G-Staff-1

Reference(s): GA Analysis

On July 24, 2017, the the OEB issued a new GA Analysis Workform for 2018 IRM applications. Given that Alectra filed its application before this date, please file a completed copy of the GA Analysis Workform for each Rate Zone.

Reference(s):_Innovative Customer Engagement Report - Appendix 1.0 Enersource Telephone Survey Report, Residential 5-Year Capital Plan DSP, Pages 17-21

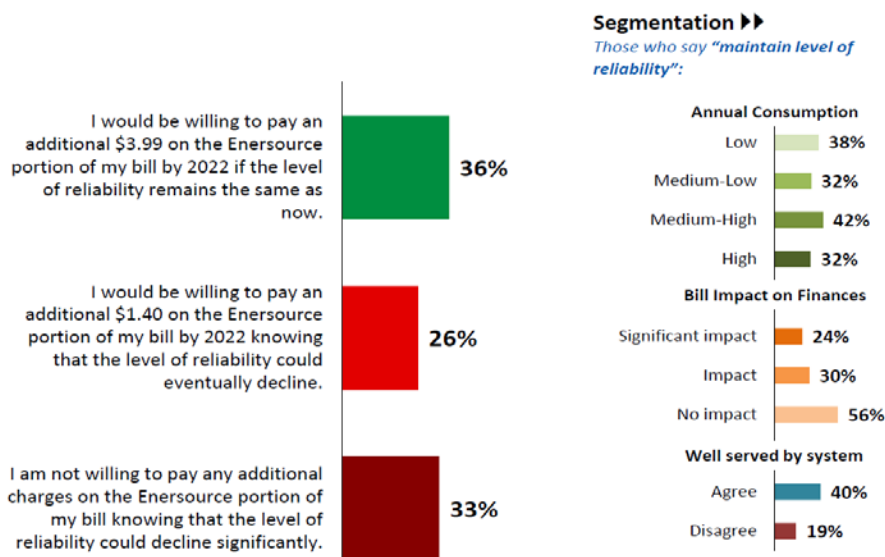
Pages 17-20 for the most part indicate some level of support for investment in system renewal, general plant, system service and modernizing the distribution system. This being said, the results from the DSP investment alternatives provided are reproduced below which show that a similar amount of customers are not willing to pay any additional charges when compared to those who are willing to pay an additional \$3.99 by 2022 (the rest are willing to pay about half).

a) Please reconcile the two results.

5) Asset Management

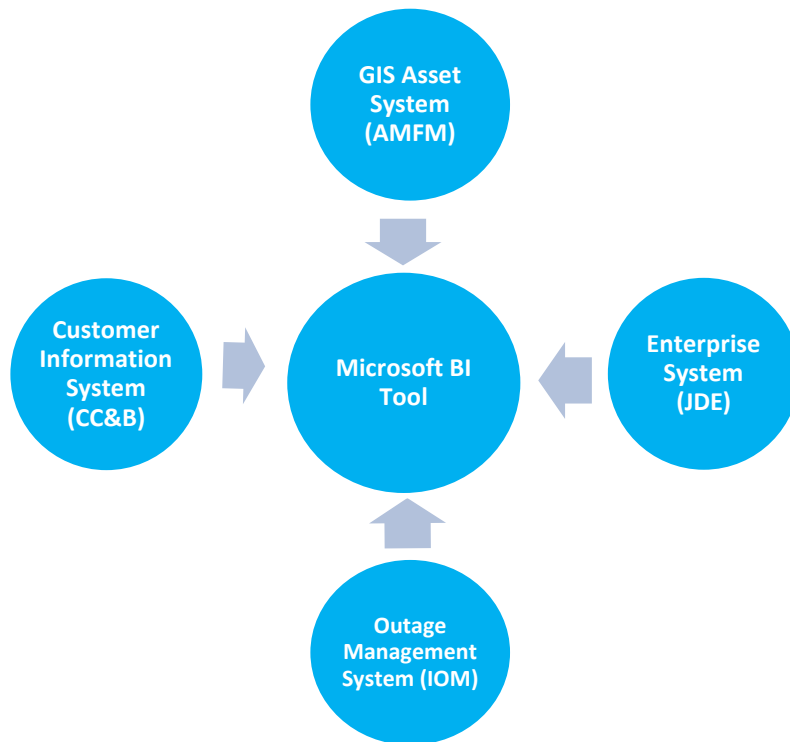
a) Please describe in detail how Alectra plans to enable asset analytics through integration of information systems.

Figure 12 - Per-Unit Cost of Transformation Installation

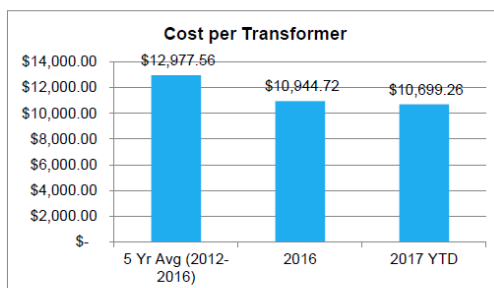
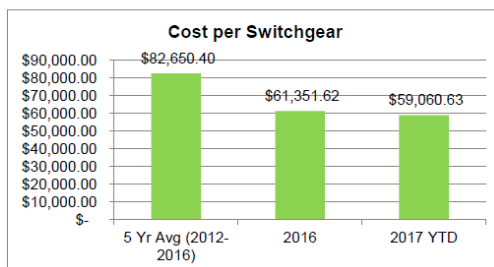
Please describe the cost elements comprising the achieved transformer and switchgear savings indicated in Figures 12 and 13 above.

Figure 62 - Main Feeder Cables Health Index Distribution

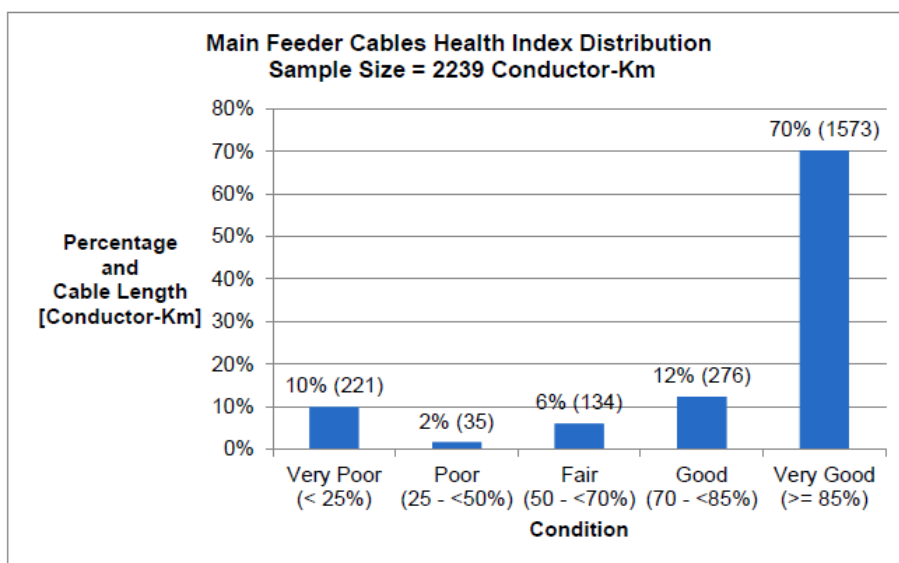
- a) Please discuss whether the Health Index Distribution in Figure 62 may be exaggerating the pool of Very Poor condition assets relative to the pool of Poor condition assets. What defining measure or parameter separates the two pools?
- b) Please provide an updated Figure 62 with Health Index Distribution based solely on performance.

- 1 b) Figure 62 cannot be plotted based solely on performance. The cable age as well as whether
- 2 the cable is direct buried or in duct are the only criteria used for cable health indexing and a
- 3 derating factor is introduced to modify the overall cable health index based on the past
- 4 history of failures of cable.

Figure 94 - Enersource RZ Peak Demand Forecast - North 27.6kV Distribution System – Extreme Weather Scenario (1996-2035)

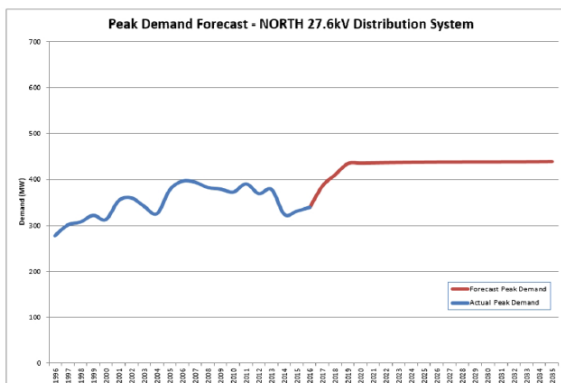
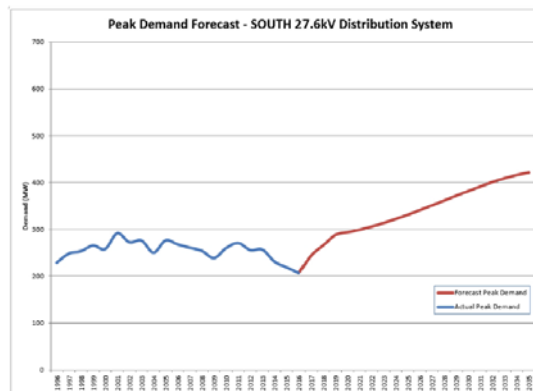
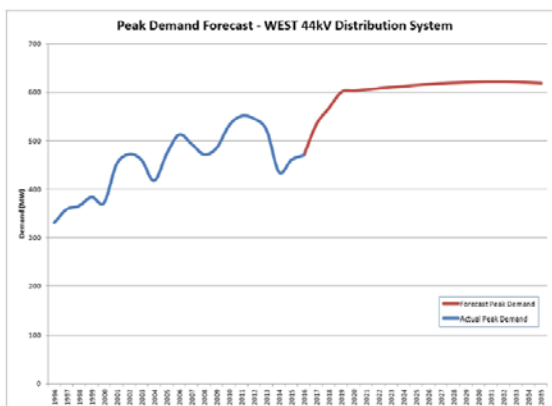
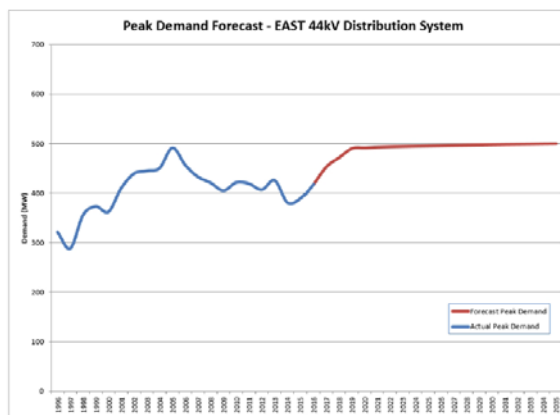
- a) The load growth forecast for years 2017, 2018 and 2019 shown in Figures 94, 95, 97 and 101 above seems high relative to actual load growth over the most recent 5 historical years. Assuming that the peak demand data for summer 2017 is now available, please provide updated Figures which include a comparison between Alectra's 2017 forecast loads and the actual year-to-date peak demand.
- b) The growth projections in Figure 101 show an increase in peak demand to approximately the same level as the historic peak. Please explain if the existing infrastructure is able to accommodate the forecast peaks? If no, why not?

Please see the updated figures with the latest summer peak information

Figure 110 - Trend of Cable Failures in Number of Failures

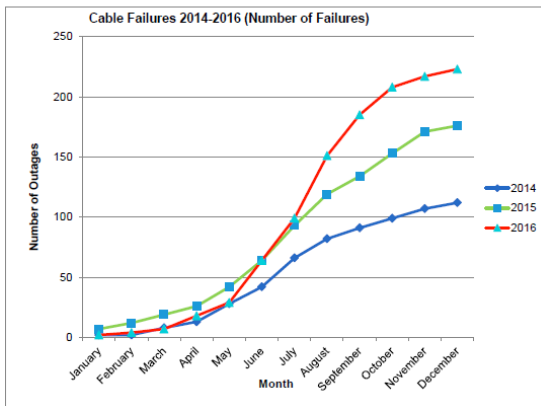
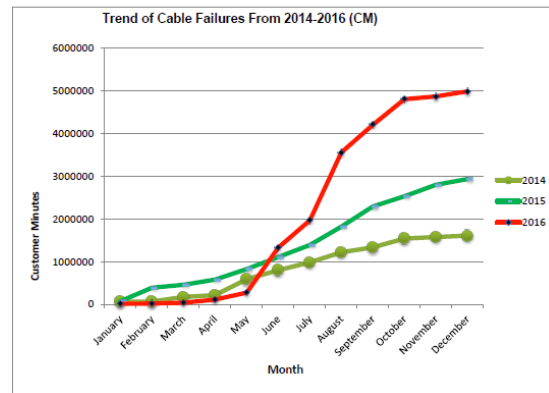
Please provide updated Figures 110 and 111 showing how 2017 cable failures are trending to date.
